Title: BRIEFING ON STAFF COMMENTS ON DOE SITE
CHARACTERIZATION PLAN FOR YUCCA MOUNTAIN

Date: JULY 11, 1989

COMMISSION BRIEFING
ON THE
NRC REVIEW OF
THE DOE
SITE CHARACTERIZATION PLAN
FOR YUCCA MOUNTAIN
NYE COUNTY, NEVADA
JULY 11, 1989

Figure 2-48. Faults and fractures at Yucca Mountain interpreted from electrical resistivity data. Clipping shows zone of inferred fracturing and faulting along Drill Hole Wash; fault trends appear to change abruptly across this zone. Modified from USGS (1984)

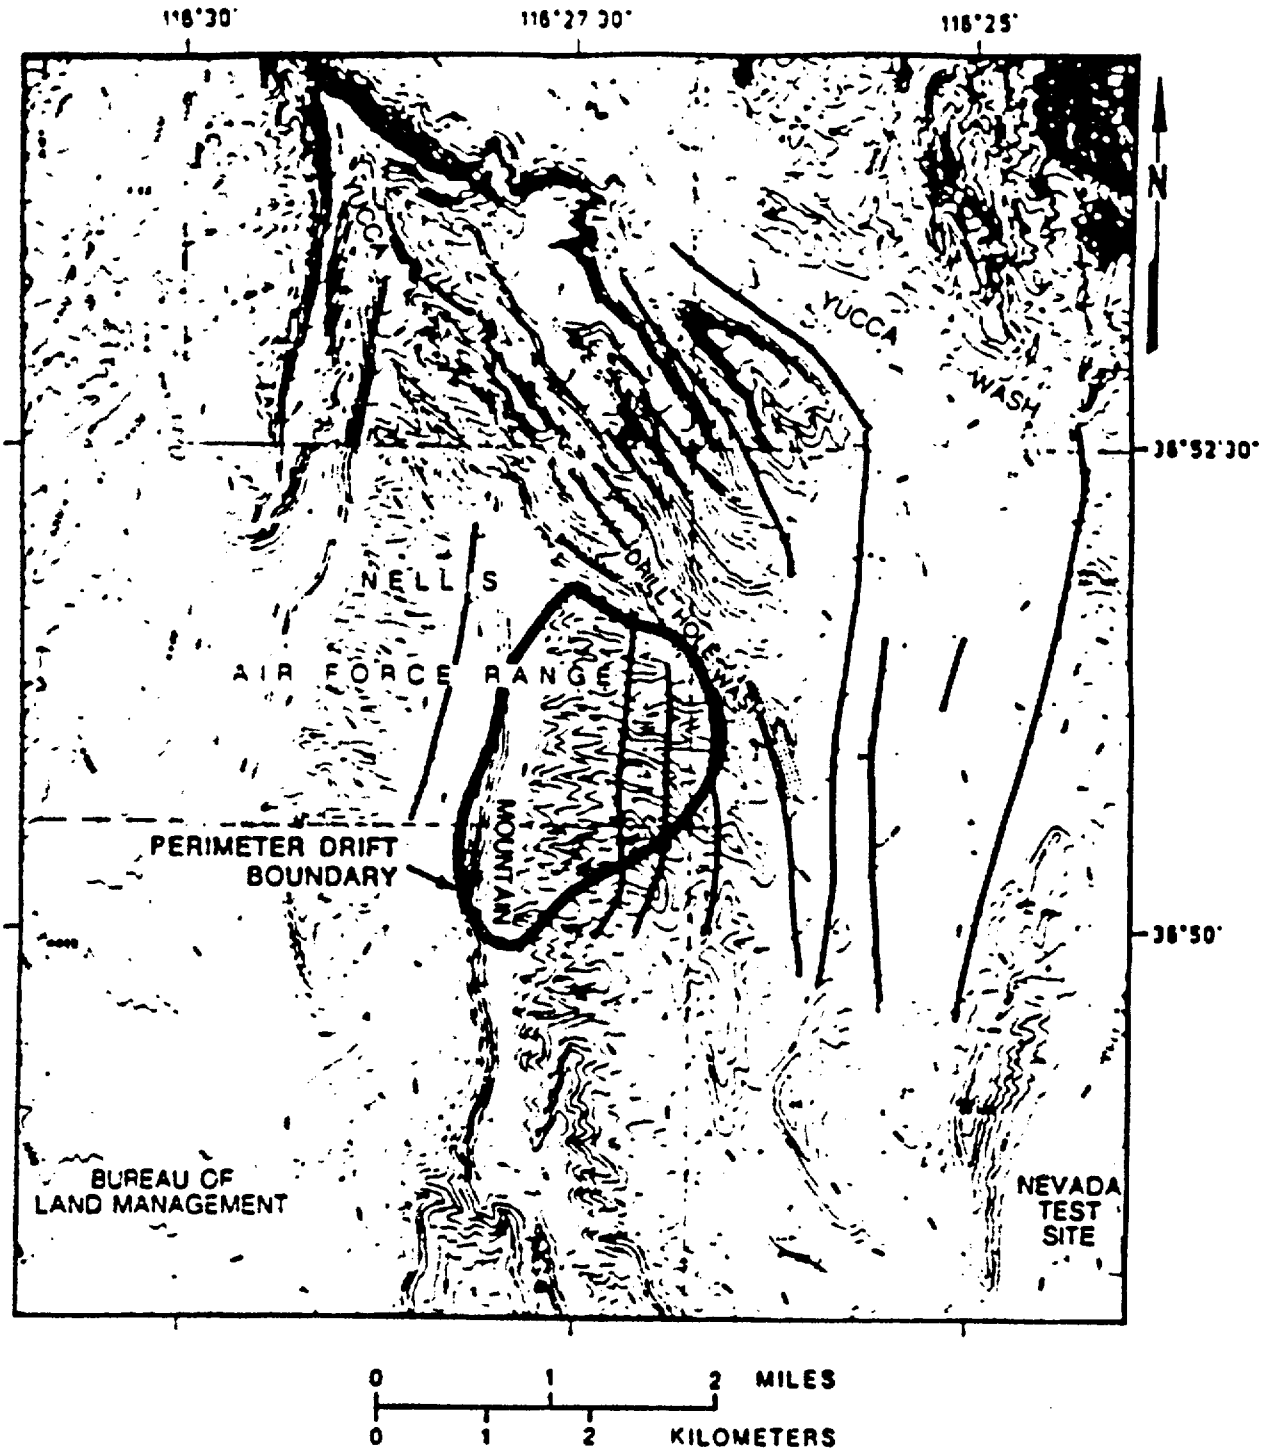
17 Now, they are already working, and the next
18 figure, page 9, is a map that you may have seen before
19 from the site characterization plan and from
20 correspondence related to the case. DOE is already
21 working at the site on the geologic anomaly or fault.
22 If you look at the circle -- not a circle but sort of
23 an ellipse of this site boundary and you see three
24 vertical lines, the center line is what some people
25 call the no name fault. It's a geological anomaly.
